UNITED STATES PATENT AND TRADEMARK OFFICE

APPLICATION NO.	FILING DATE	FIRST NAMED INVENTOR	ATTORNEY DOCKET NO.	CONFIRMATION NO.
09/971,131	10/04/2001	James C. Tuthill	21488/04040	4066

Office Action Summary	Application No. 09/971,131	Applicant(s) TUTHILL, JAMES C.	
	Examiner Brian Walsh	Art Unit 3722

DETAILED ACTION

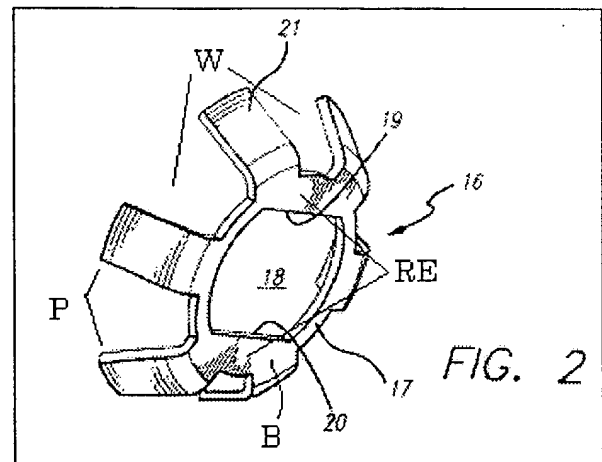
5. Claims 3, 9, 11, 14 and 15 are rejected under 35 U.S.C. 112, second paragraph, as being indefinite for failing to particularly point out and distinctly claim the subject matter which applicant regards as the invention.

In claims 3, 9 and 14, the Examiner contends that the phrase "D-shaped" is unclear. In claim 11, the Examiner notes that the use of the limitation "T-shaped" is unclear. It is possible for the limitations "D-shaped" and "T-shaped" aperture to be interpreted in a number of ways. The Examiner notes that the aperture, as shown in figures 2 and 3 as (27) and (34), appears to be a truncated circular aperture. Claims 3, 9, 11, 14 and 15 will be examined as best understood.

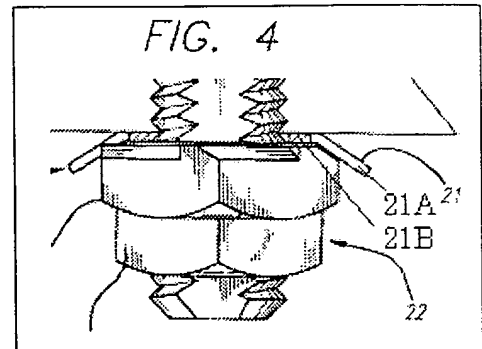
configuration. Duran also discloses the base section (B) defines a central aperture (18) and wherein the peripheral section (P) includes a plurality of fingers (21) which define one or more longitudinal windows therebetween. The fingers (21) include nut engaging surfaces on the interior surface of the peripheral section. It is clear from figure 2, Duran further discloses the fingers include a flared end bent towards the center of the spindle nut retainer.

Regarding claim 2, it is clear from figures 4 and 10 that Duran discloses the nut engaging surfaces each comprise two angled surfaces (21A, 21B). Please refer to a partial capture of figure 4 to the right.

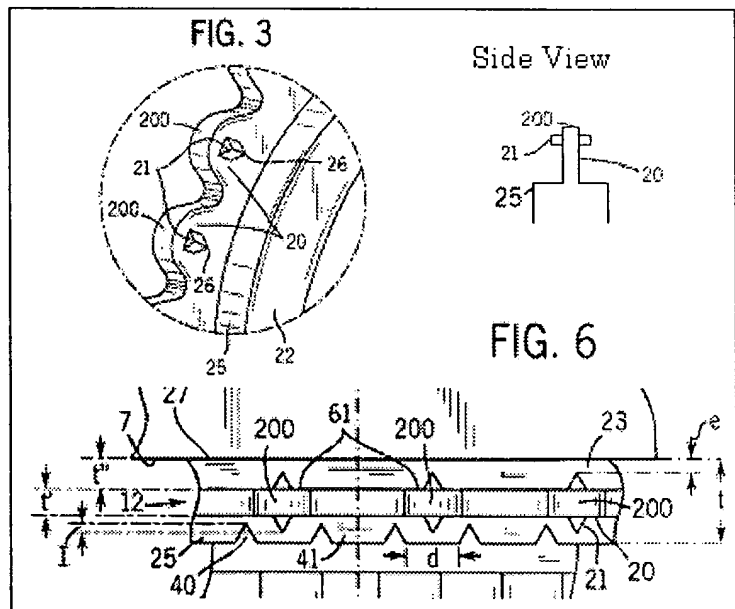
Giachinta et. al. discloses a retainer (12) for preventing disengagement of a nut (14) to a base (2). Giachinta et. al. discloses a peripheral section (200 in figure 3) including an integrally formed ring (25 in figure 3) at an end opposite the base section (23 in figure 6).

Giachinta et. al. discloses a retainer (12) for preventing disengagement of a nut (14) to a base (2). In figures 3 and 6, it is clear that Giachinta et. al. discloses the fingers (200) have protrusions (21) on both a first and second side. When seen from a transverse view, the fingers would appear to have a "T-shape." Please see the attached drawings.
